Permit Number: 090498

This is to certify that 500 RIVERSIDE ASSOCIATES/Warren has permission to interior renovation and expansion of office area with ware house AT 524 RIVERSIDE IND PKWY

Project: Envirologix Renovations
Riverside Industrial Parkway

Enviro Logix Second Floor Expansion
530 Riverside Industrial Parkway
Portland, Maine

3 STAIR DETAIL
A5.1

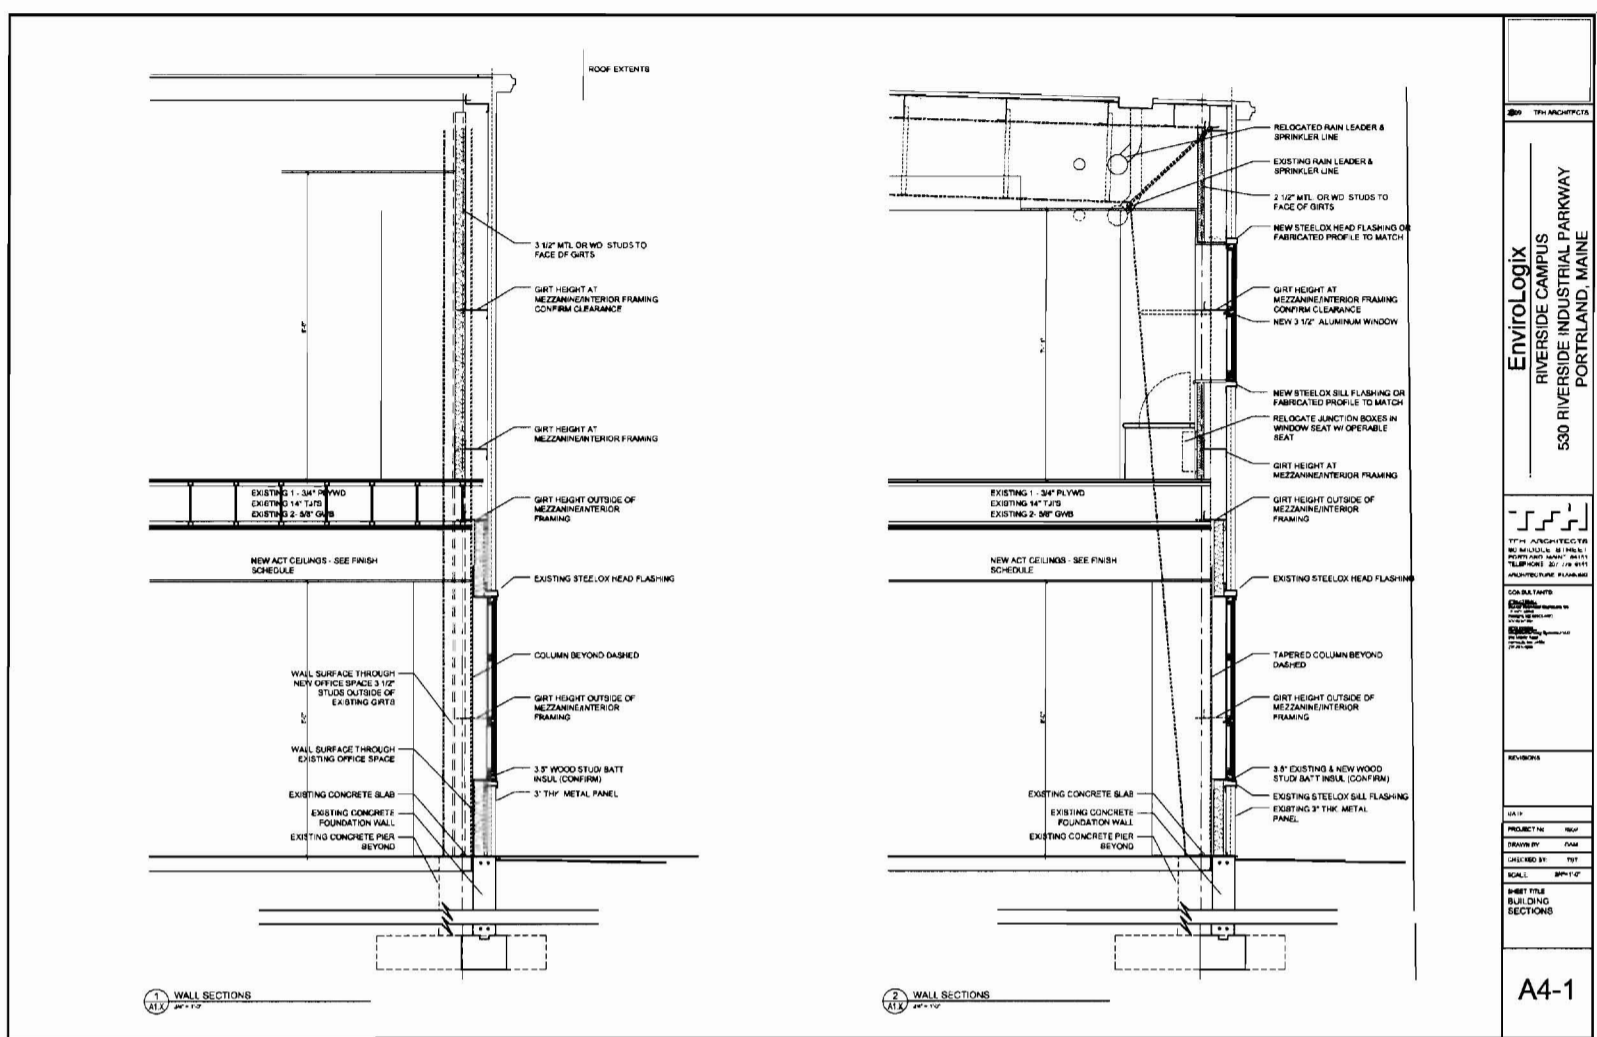
6/24/2009-jmb: Spoke with Dave M. For detail on stair profile, guardrail detail at open deck and new window opening detail. He will email pdf's.

Attached are a blow up of the stair detail, a pair of guard rail details and the building exterior wall sections with window placement. As I mentioned the guardrail will be selected based on final costs. I apologize for the mismatched paper sizes if you would like hard copies please let me know or if you have any questions or need further clarification please call.

1 SECOND FLOOR FRAMING PLAN
 S1-1

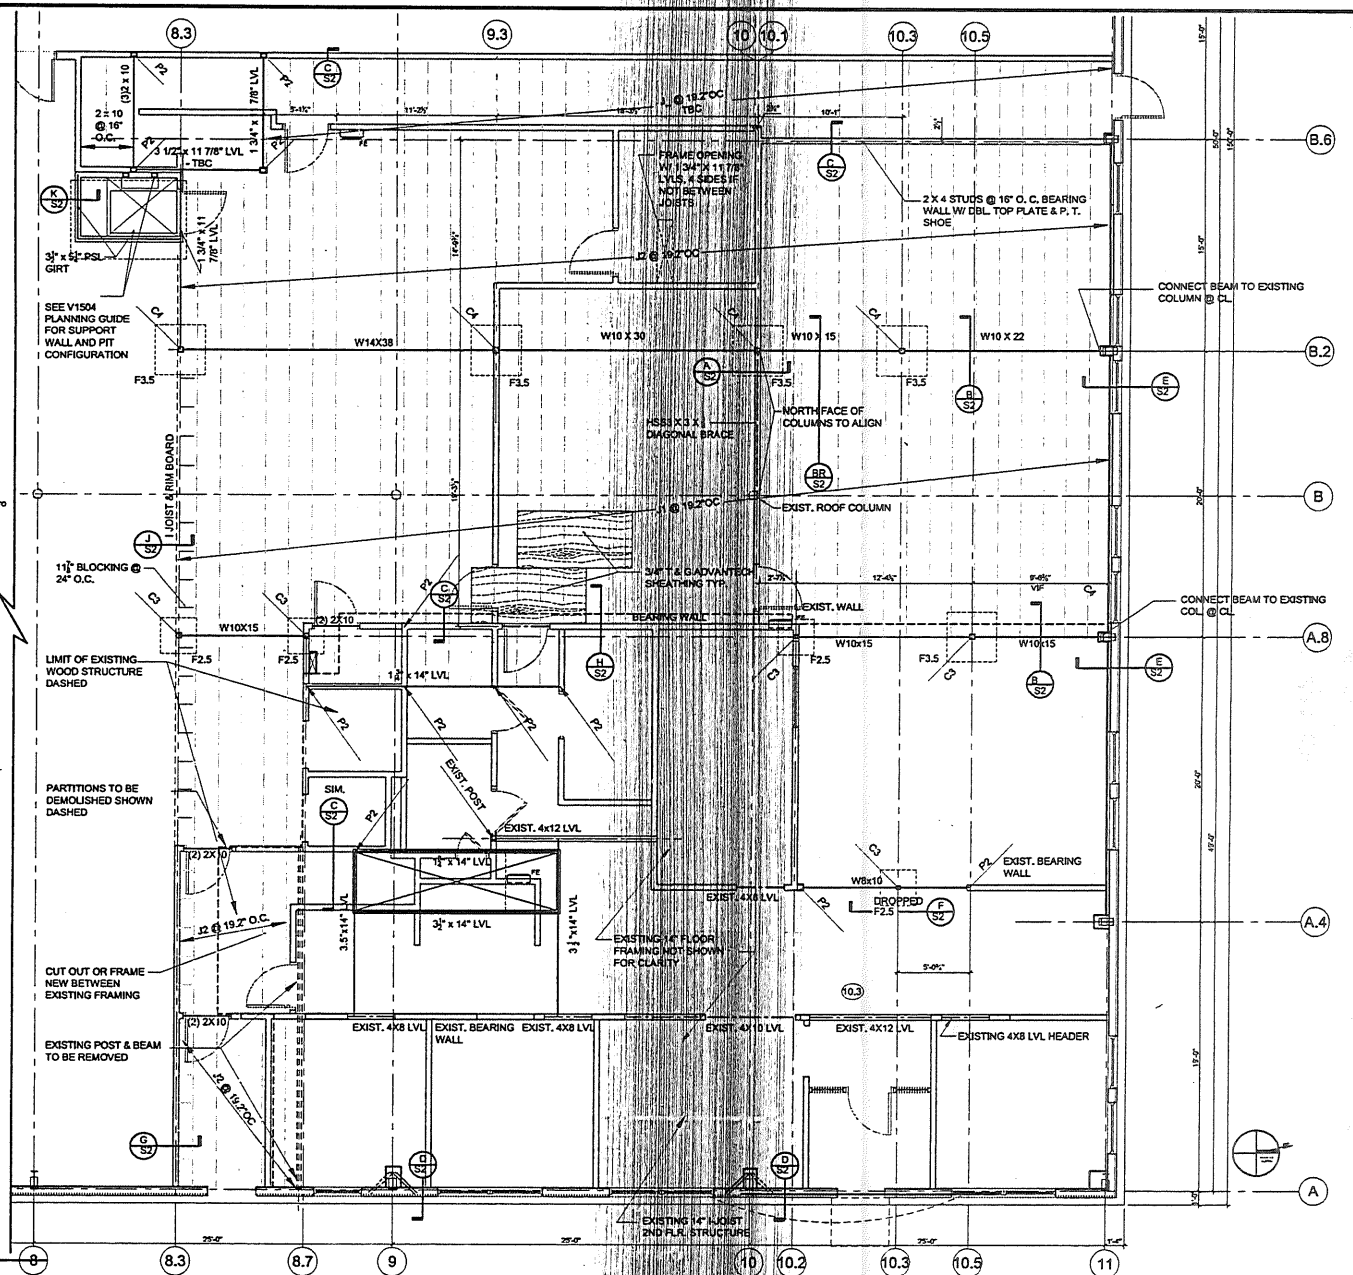
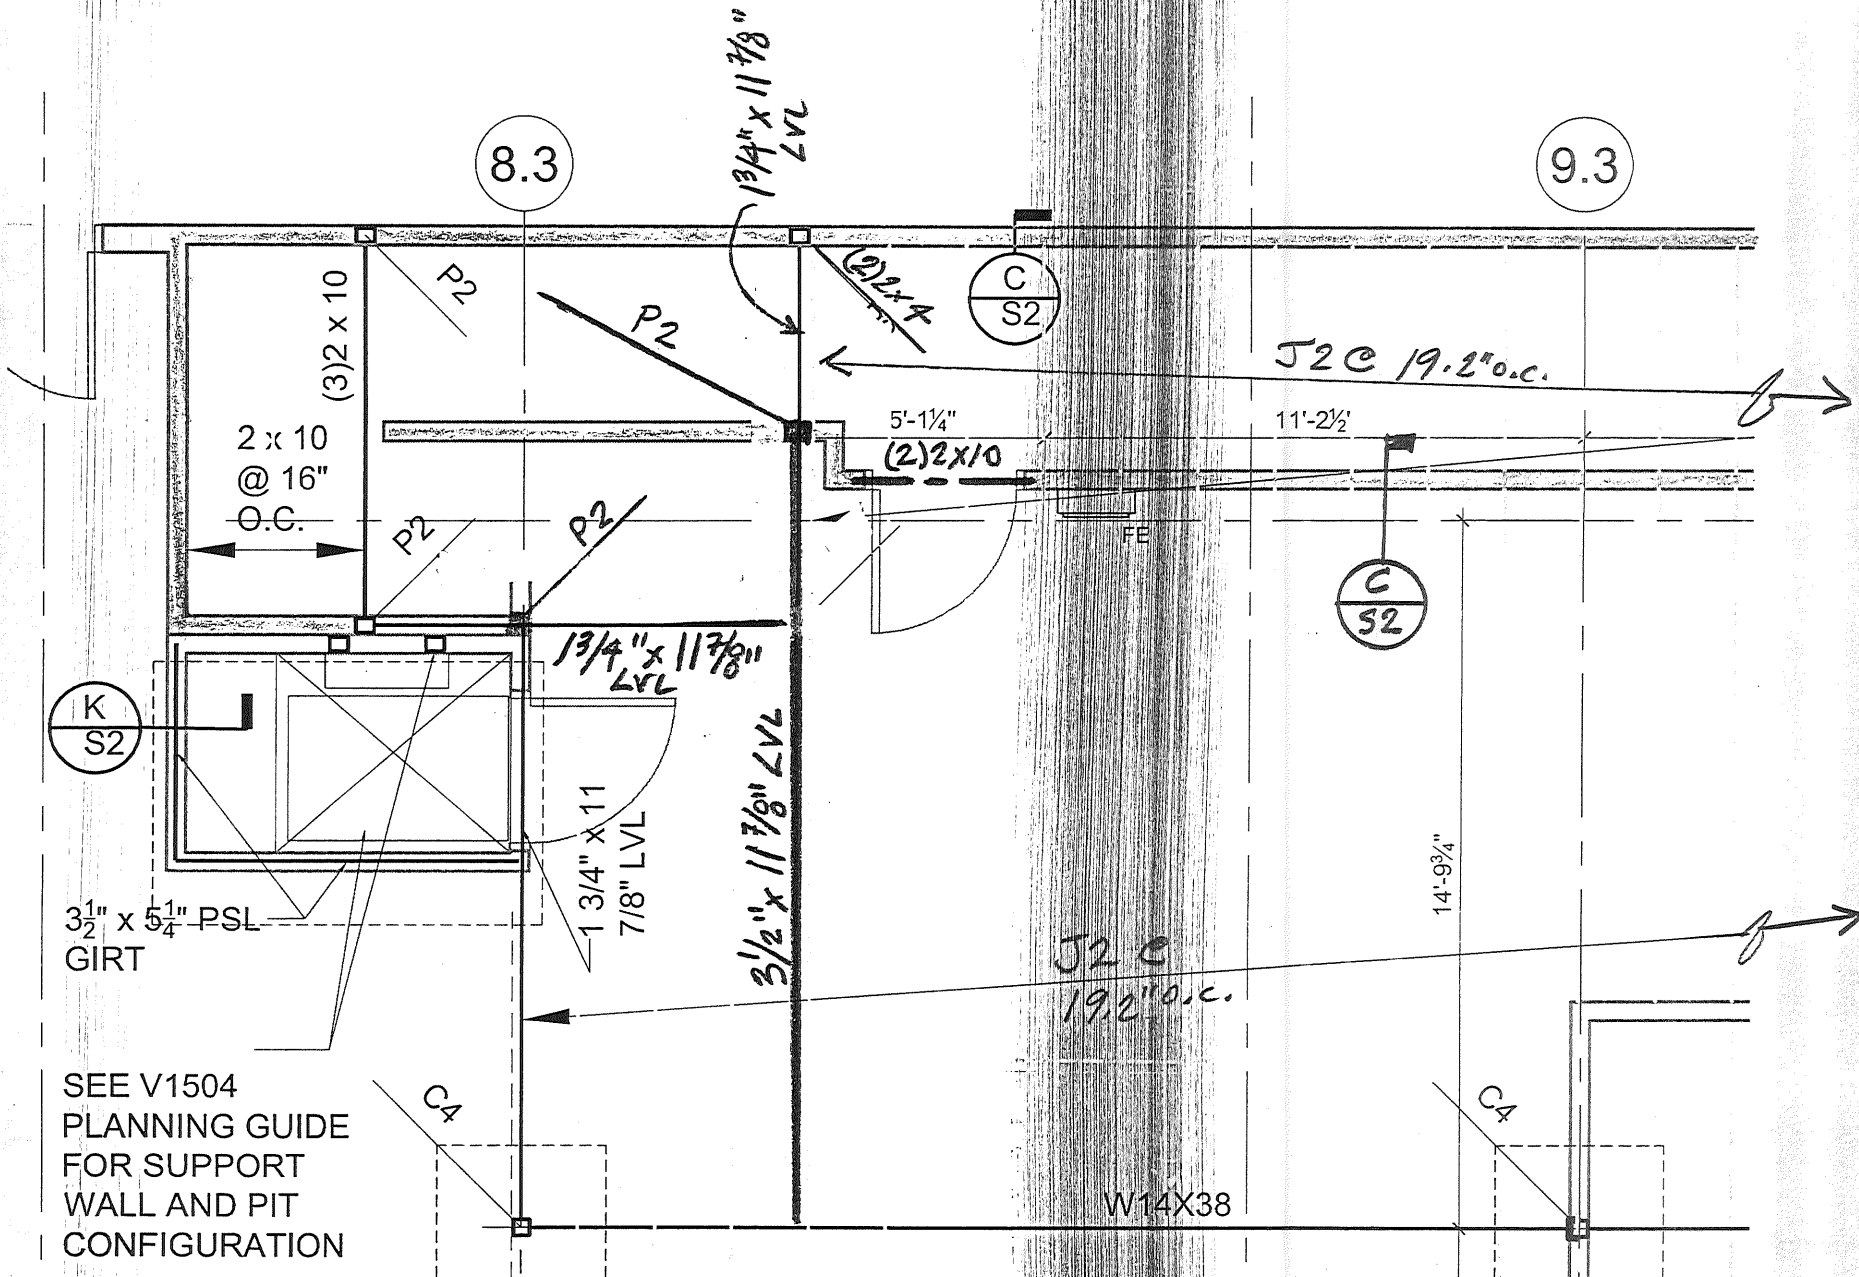
F3.5 footings: Quantity specified on drawing S1 is incorrect. I asked Dan Simpson to provide (2) #4 bars (one each way) at each F3.5 footing.

SSK-4

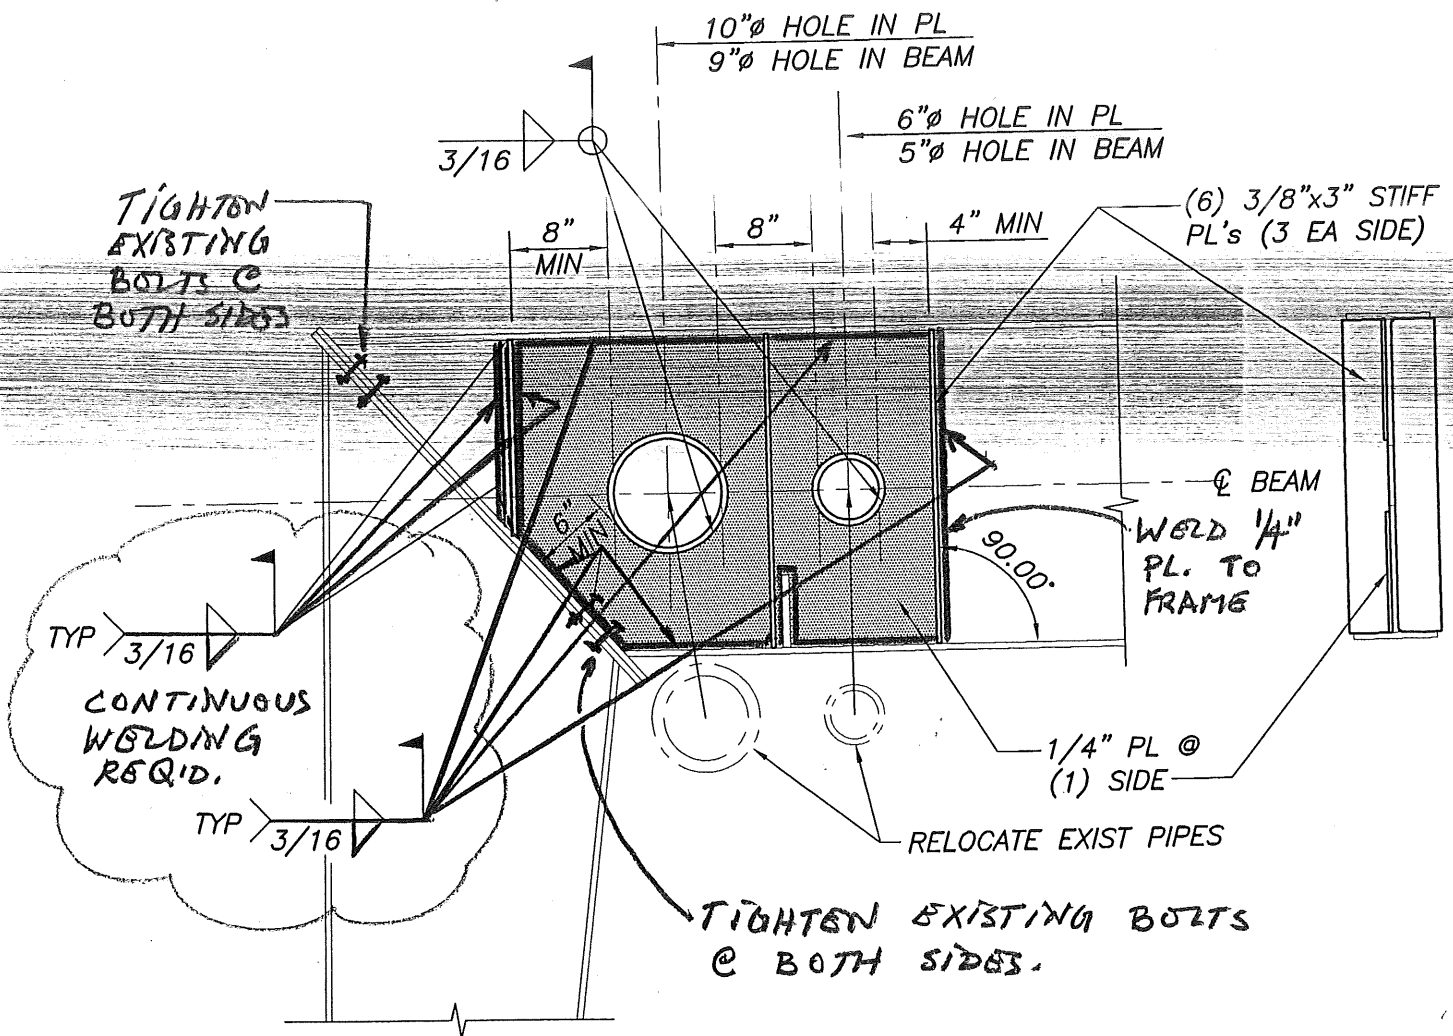
Incomplete welding of plates at existing frames for pipe penetration holes. Discussed with Ken Hough at site. Welding is to be completed as shown on detail sketches SSK-4 & SSK-5.

Welding of ¼ steel plates is complete at two existing frames for pipe penetration holes as shown on detail sketches SSK-4 & SSK-5.
